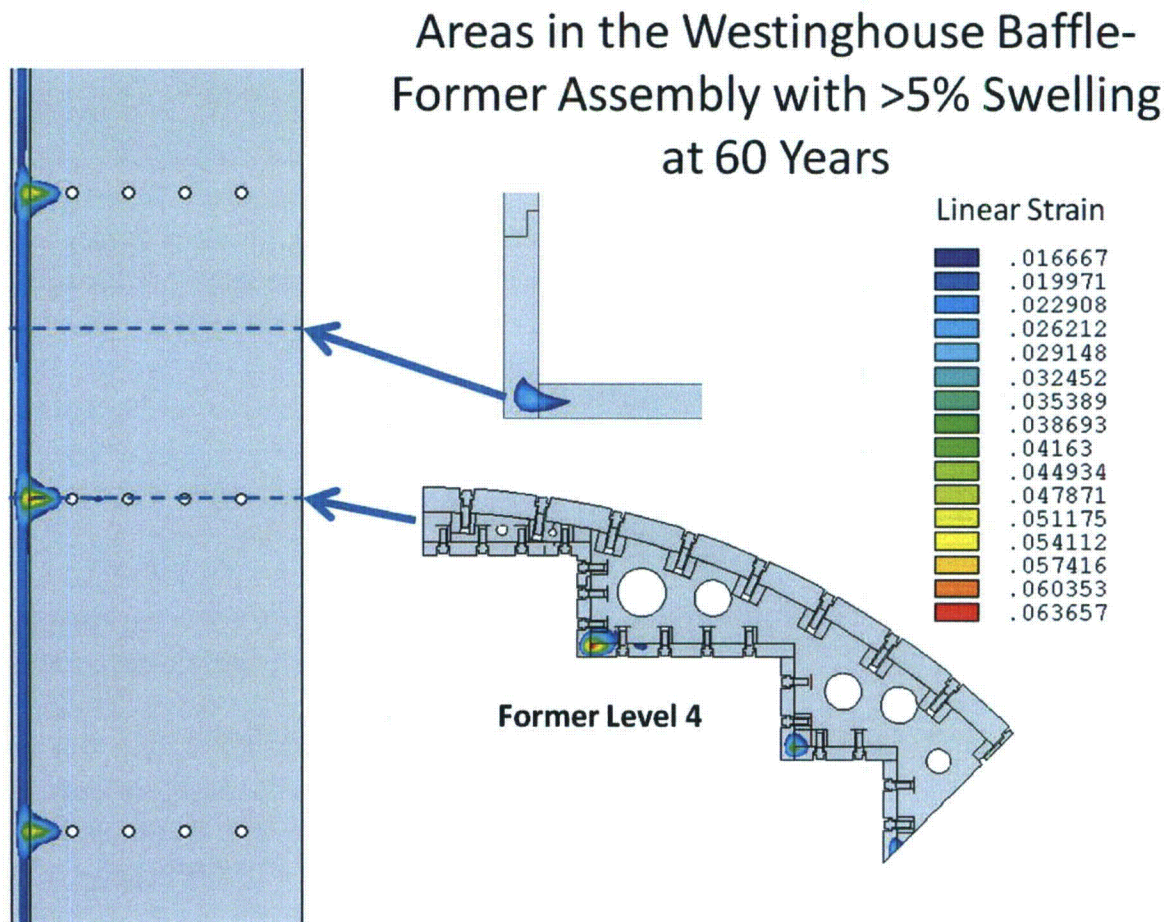
RAI 4-18: As a follow-up to RAI-26 (second set of RAIs), please clarify if components that are predicted to locally exceed 5% swelling by volume are inspected for cracking at those locations. Provide justification why any such components that exceed this criterion are not recommended for inspection.

Response: For the B&W design, there are no locations predicted to locally exceed 5% swelling by volume. From the CE and Westinghouse designs, the MRP-227 I&E Guidelines monitor the distortion caused by the integrated effects of void swelling over the entire volume of a PWR internals assembly. The inspections that implement this requirement are shown in Tables 4-2 and 4-3 of MRP-227 for Combustion Engineering and Westinghouse plants, respectively. The inspections focus on the regions of high swelling and locations where the accumulated effects of swelling over the assembly are most likely to be visible. The particular distortions that led to the recommendations were the result of the functionality analyses reported in MRP-229 and MRP-230.

These functionality analyses showed that the volumes of material for which relatively high “effective irradiation strain growth” was calculated were very small and localized, to regions of combined high fluence, high gamma heating, and limited cooling. (Note: the volumetric swelling is equal to 3x the irradiation growth strain.) In the Westinghouse design, the high swelling regions were limited to high fluence seams where there are joints between the baffle and former plates. Typical Westinghouse high fluence regions are indicated in the accompanying figure. MRP-227 requires VT-3 examinations of the baffle-former assembly and the baffle-edge bolts at these locations. Even though the FEA aging evaluation included these levels of swelling, the analysis did not indicate stresses high enough to initiate IASCC in these components. The high swelling locations are remote from significant structural load paths and cracking at these locations is not expected to have a significant structural impact. Therefore it was determined that the

A similar situation occurs near the mating surfaces of the upper and lower core shroud former plates in the CE design (MRP-227 Figure 4-14). The MRP-227 guidelines require inspections of the joint for observable distortion and the adjacent welds for cracking. Because the welds are considered a structural element, the requirement is for an EVT-1 inspection at the joint.

Figure 1: Consequence vs. Susceptibility for Ranking *Note: There are no component items in the B&W-design internal with an assigned safety consequence metric equal to 4; therefore, the last row of this figure is not applicable to the MRP effort.

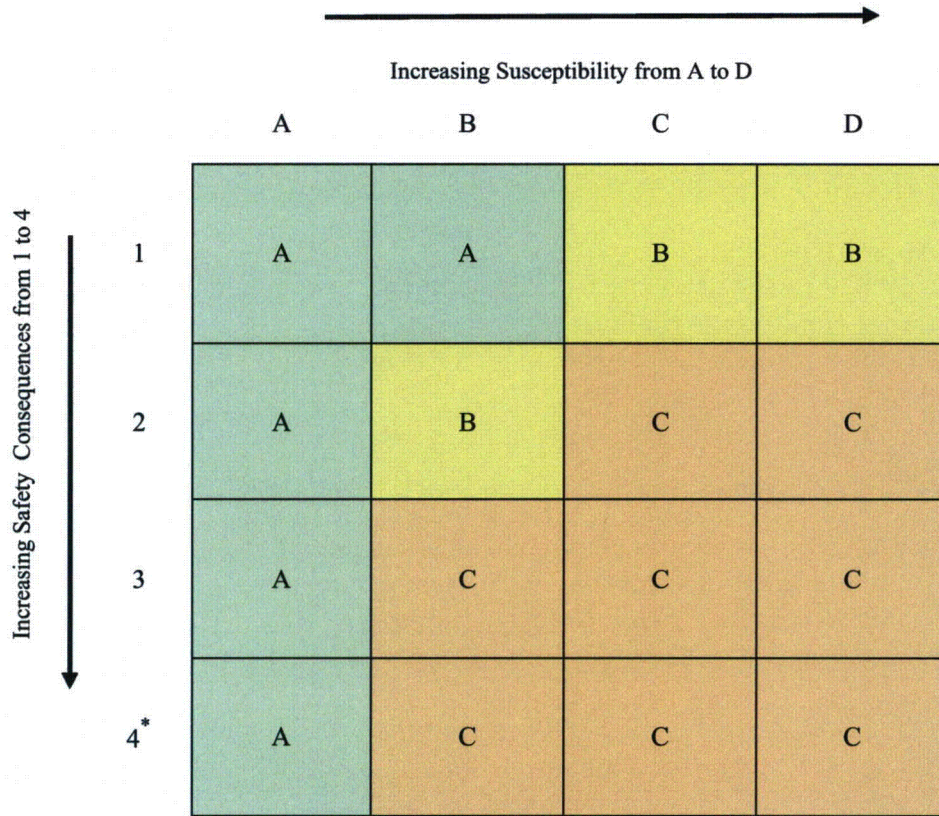
The risk matrix in MRP-189 Rev. 1 (Figure 4-1) does not include a column for the susceptibility metric value of "A" because, as noted in MRP-190 (Section 3.2), the "A" (or Category A) events are deemed so improbable (very, very low likelihood of occurrence) that the safety severity of consequence metric was not evaluated, implying that even if there was an adverse consequence, the risk impact would be insignificant. However, to clarify how component items were categorized, the Figure 1 below provides a correlation to the risk matrix (Figure 4-1 of MRP-189 Rev. 1) and also includes a column for Category A items:
